## Illabo to Stockinbingal (I2S) EIS - Submission

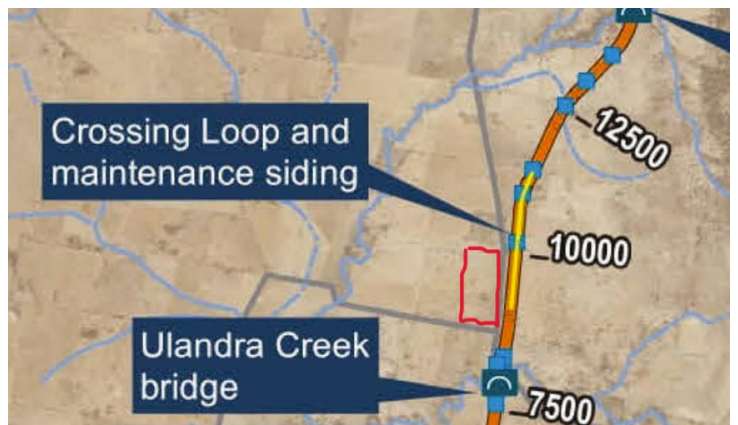
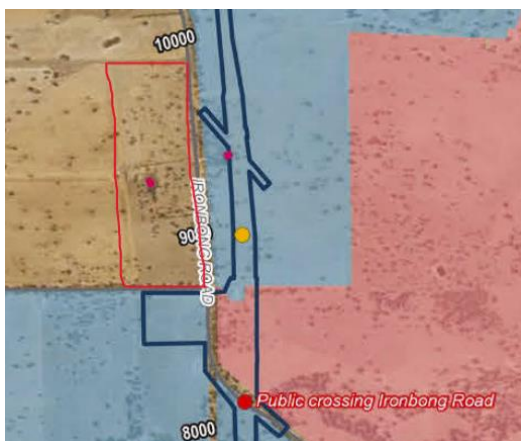
Our property is 100 acres and runs parallel to the proposal. The front door of our house will be approximately 400m from the line and within 200m of our property's boundary fence. Our farm runs about 30 stud Simmental breeding females and their calves, which are produced for the beef cattle seed stock industry. We have our annual on-farm cattle sale at our family's farm about 25 kilometres from our property. Below are some images from the EIS and ARTC Inland Rails website showing our property location in relation to the proposal. The four images below indicate our property within the red rectangle.

Considering the proximity of our house and property to the proposal, we cannot understand how the location is justified. How was the location of our house considered in the identification of the alignment? We appear to be among the many grossly affected properties by the greenfield section of rail (which is not being acquired) by virtue of the location of the following aspects of the proposal:
